SUBJECT: DAVIS-BESSE NUCLEAR POWER STATION, UNIT 1 - REQUEST FOR
RELIEF FROM AMERICAN SOCIETY OF MECHANICAL ENGINEERS BOILER
AND PRESSURE VESSEL CODE REQUIREMENTS FOR THE THIRD
10-YEAR INTERVAL INSERVICE INSPECTION PROGRAM (TAC NO. MB5849)

SAFETY EVALUATION BY THE OFFICE OF NUCLEAR REACTOR REGULATION

REQUEST FOR RELIEF NO. RR-A2

TECHNICAL LETTER REPORT
ON THE THIRD 10-YEAR INTERVAL INSERVICE INSPECTION
REQUEST FOR RELIEF NO. RR-A2
FOR
FIRSTENERGY NUCLEAR OPERATING COMPANY
DAVIS-BESSE NUCLEAR POWER STATION, UNIT 1
DOCKET NUMBER: 50-346

Figure 1 Sketch depicting Code-required axial (1 and 2) and circumferential (3 and 4) scanning directions.

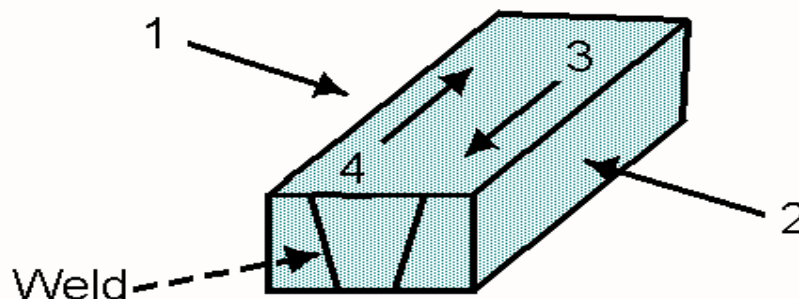
Article 4, Section V of the ASME Code, 1995 Edition, 1996 Addenda requires the weld and adjacent base metal to be examined using nominal angles of 45 and 60 degrees, (deviation is permitted if geometry limits the coverage, however, separation of angles must be at least 10 degrees) and a straight beam. Four basic scan directions are required for the angle beams; two perpendicular to the weld axis (axial scan) from opposite directions and two parallel to the weld axis (circumferential scan) from opposite directions. These requirements apply for each of the angle beams used (i.e., 45 and 60 degrees). Each of the 45 and 60 degree angle beams is required to pass through all of the weld volume in the four basic scan directions. However, the adjacent base metal [base material along each side of the weld] scanning requirements allow the two beam angles to pass through in only one direction each for the axial and circumferential scans. In addition to the Code-required examinations, the weld is also scanned with a 65 degree transducer to provide examination perpendicular to the weld/base metal interface as required by NRC Regulatory Guide 1.150.

The examination volume for the Reactor Head-to-Flange Weld is defined in Figure IWB-2500-5. The examination volume can be scanned along the weld axis from two

directions. However, due to the extreme angle of the transition from the curvature of the head base material to the flange, access for scanning perpendicular to the weld axis is restricted to only the head side of the weld. From the head side of the weld, the service structure support skirt restricts scanning a portion of the examination volume with one of the two required angle beams. Scanning with the other required angle beam is not affected by the service structure support skirt.

Figure 2 Cross-sectional view of Weld WH-7 showing weld area (2) and base metal examination (1 and 3) zones.

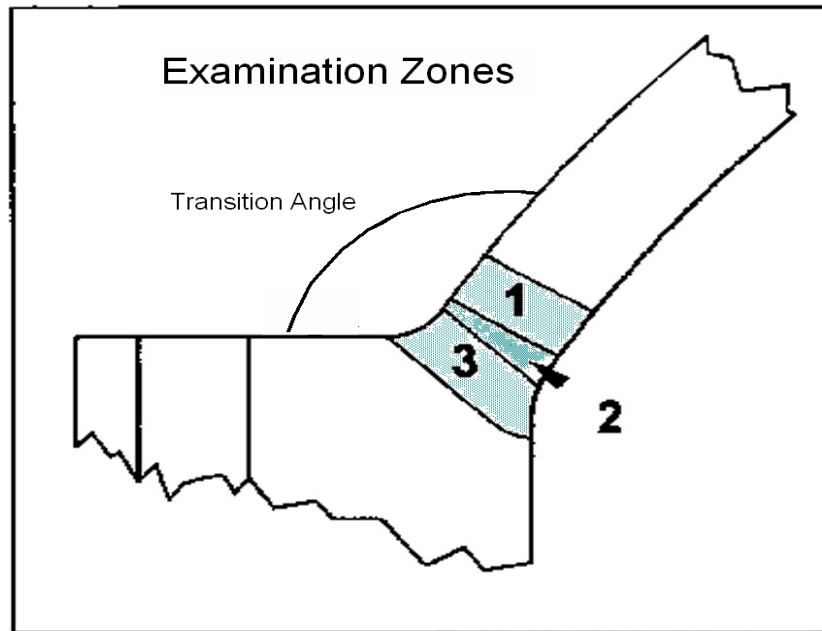
The component consists of an ASTM A-508, Class 2 forged ring (RPV bolting flange area) attached with a full penetration weld to an ASME SA-533, Class 1 forged, dome-shaped head. The cross-sectional geometry of the component at Weld WH-7 (see Figure 2) produces a high transition angle between the flange and the domed head. Scanning from the flange side may not provide the necessary angular orientation to detect flaws that are expected to initiate from the inner or outer surfaces and grow along the general orientation of the weld. In addition, the location of three closure head lifting lugs and a stamped directional marker (see Figures 3 and 4) further restrict access for ultrasonic examination. For these reasons, the component configuration does not allow the licensee to obtain the full Code-required volumetric coverage from both sides of the weld. For the licensee to achieve 100 percent volumetric coverage, the RPV closure head would have to be redesigned and modified. This would place a significant burden on the licensee, thus the Code-required 100 percent volumetric examination is impractical for Weld WH-7.

As shown on the sketches and technical descriptions provided by the licensee, a substantial amount (approximately 80 percent) of the Code-required examination volume can be obtained with the perpendicular, parallel and 0° ultrasonic scans performed from the head side of the weld. Apart from the Code volumetric examinations, the licensee also performs a separate 65° shear wave ultrasonic inspection from the head side of the weld to produce a sound field nearly perpendicular to the weld/base metal interface (in Figure 2, this is the black line between zones 1 and 2, and separating zones 2 and 3), as recommended by NRC Regulatory Guide 1.150 *Ultrasonic Testing of Reactor Vessel Welds During Preservice and Inservice Examinations*, Revision 1, February 1983. In addition to the volumetric examinations of this weld, the licensee conducts the essentially 100 percent Code-required surface examinations on the outside of the component. While the licensee cannot meet the Code-required 100 percent volumetric examination coverage, the limited examinations completed should detect any general patterns of degradation that may occur in the areas covered, providing reasonable assurance of the continued structural integrity of this weld. Therefore, pursuant to 10CFR50.55a(g)(6)(i), it is recommended that relief be granted.
